**BEFORE THE PUBLIC UTILITY COMMISSION
OF OREGON
UE 356**

REDACTED OPENING TESTIMONY
OF THE
OREGON CITIZENS' UTILITY BOARD

June 10, 2019

1 Here is the chart for hourly prices at the California-Oregon Border (COB)⁹:

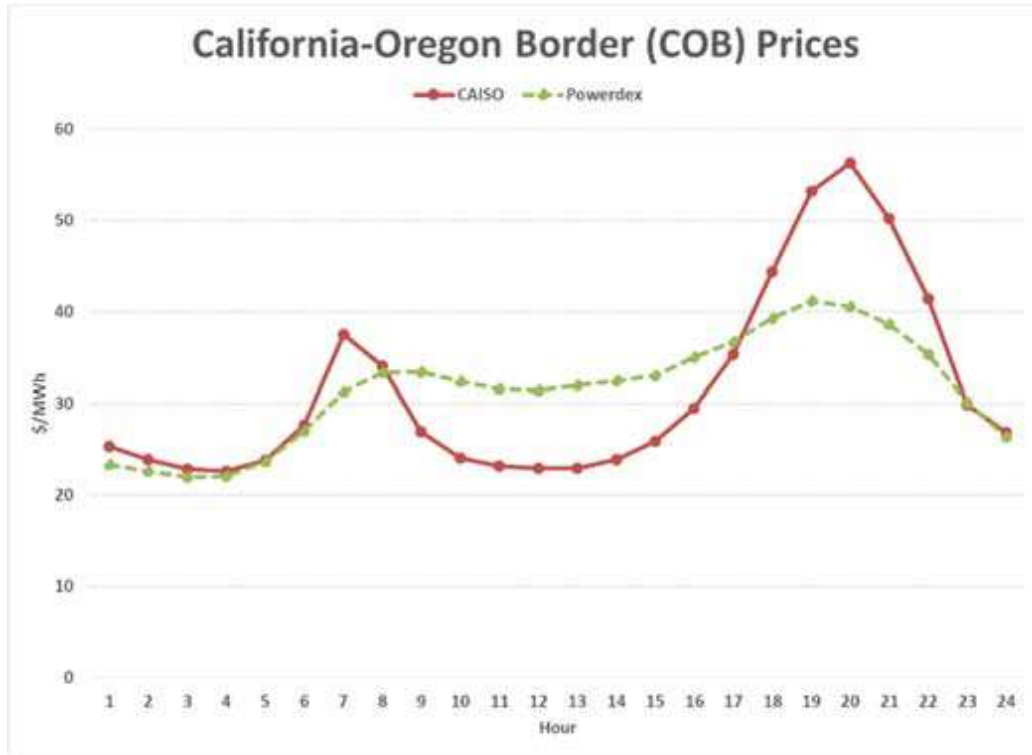
9 **A.** The Company compares the scalars using the historic PowerDex methodology and
10 its new CAISO methodology and then asserts that “as seen in the charts, the
11 updated scalars (red line) produces a more reasonable shape.”⁸ The Company
12 claims that with increasing solar penetration the CAISO methodology “better
13 reflects” market conditions. But it offers no empirical evidence that the CAISO
14 methodology produces a better price forecast.

3 The Company believes it is obvious that the red line is more accurate. The red line
4 certainly reflects California's Duck Curve, which has a significant effect on
5 California prices. However, if net load doubles between midday and early evening,
6 this does not mean that prices double. Much of the price response will depend on
7 available capacity. The green line in the chart may better represent the prices during
8 periods of available capacity.
